REQUEST FOR TENDER No. 20-062

Meadowood Community Centre Construction

**Addendum 4 (17 pages)
Issued: December 3, 2020**

ADDENDUM – 04

NORTH
1 MAIN FLOOR PLAN - SANITARY
M-02
1/4" = 1'-0"

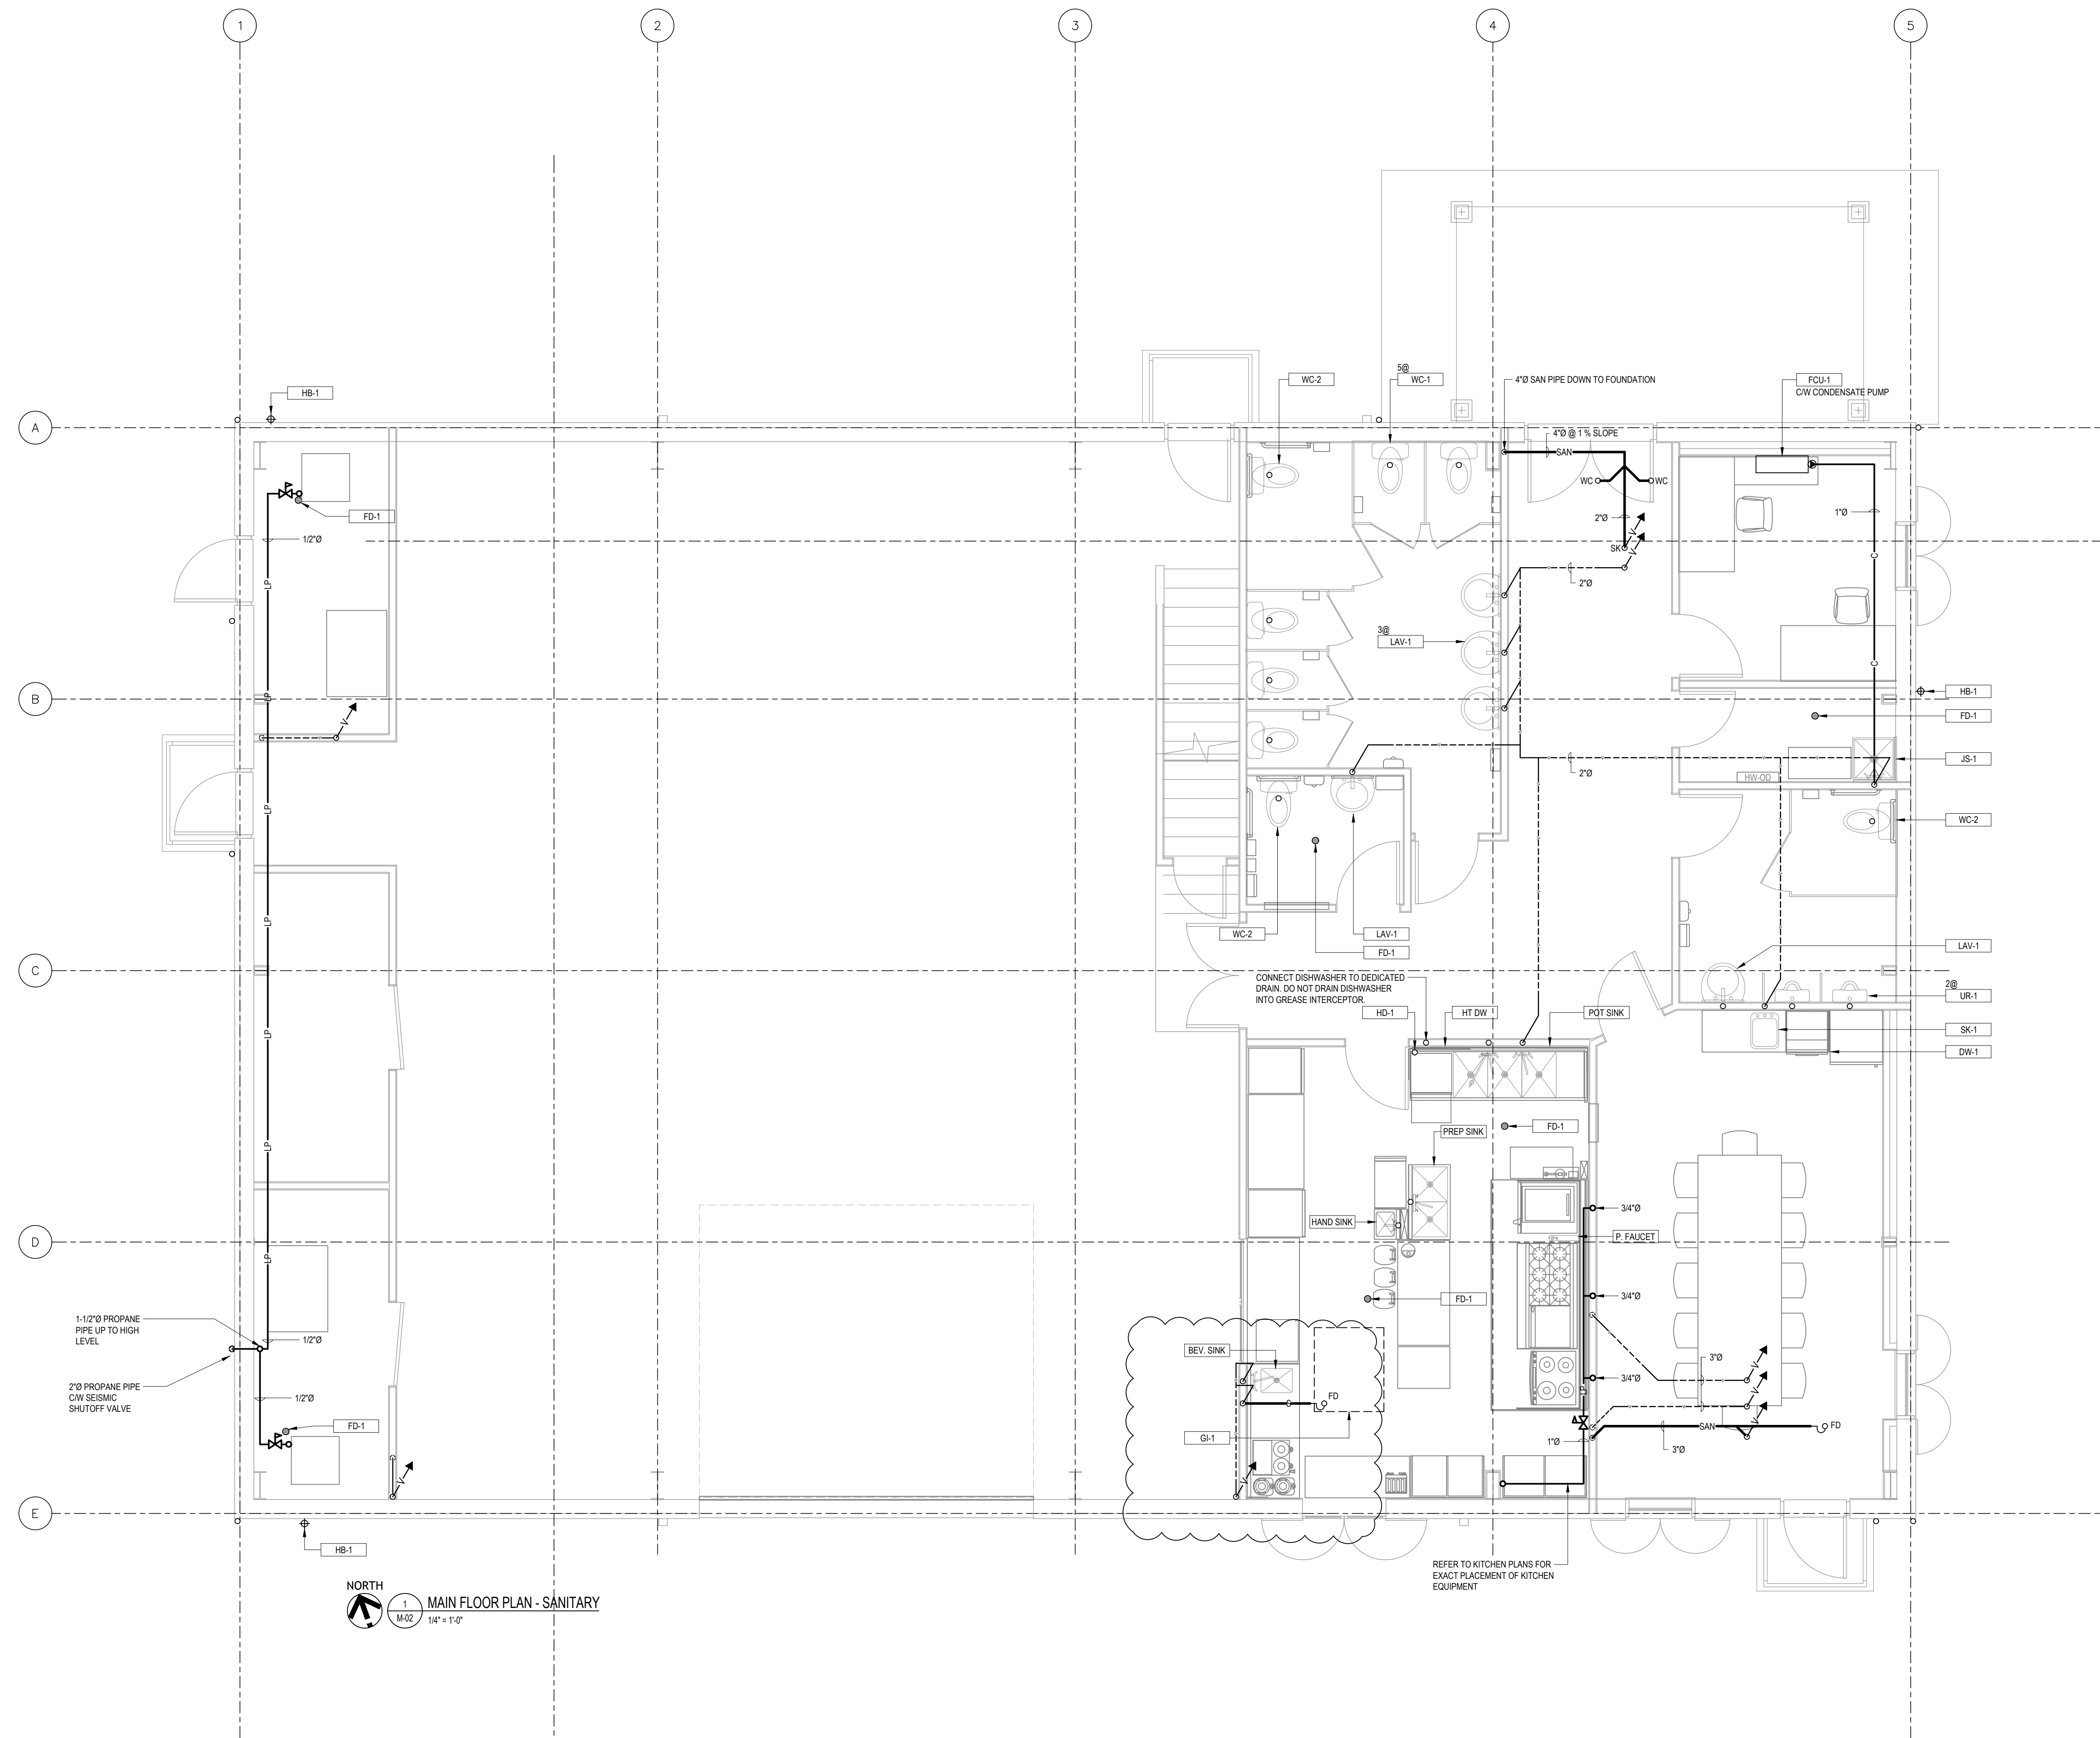
Refer to DRAWING M-2 (see attached)

| REVISE: | 1. | Revise sanitary piping from floor drain in mezzanine mechanical area. |
